# SERVICE LETTER

NUMBER: DK-3030  
(Customer documentation ref PIB DK-3024)

**SUBJECT:** STATIC DISCHARGE SPRING AND RIVETS

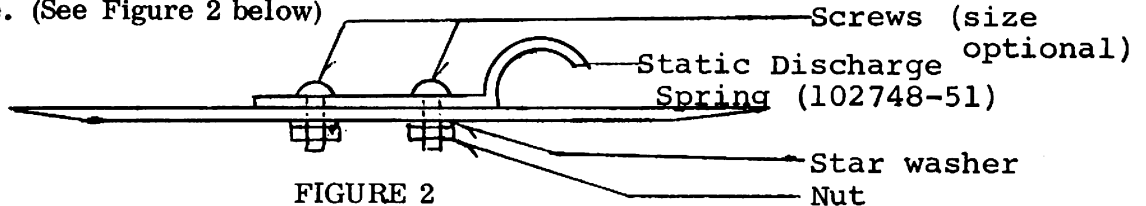
- 1.0 Remove belt guard plate from under side of drive by removing three (3) phillips screws and star washers.
- 2.0 Remove old static discharge spring and rivets taking care not to bend the belt guard plate.
- 3.0 Place new rivets and discharge spring in belt guard plate. Head of rivets must be on static spring side. (See Figure 1 below)

- 4.0 Place heads of rivets on a solid surface (preferably a steel block) and peen rivets for the tightest possible connection.

Screws may be used in place of rivets, however, if screws are to be used, drill rivet holes to exact size of screw and use star washers on the bottom side of belt guard plate. (See Figure 2 below)
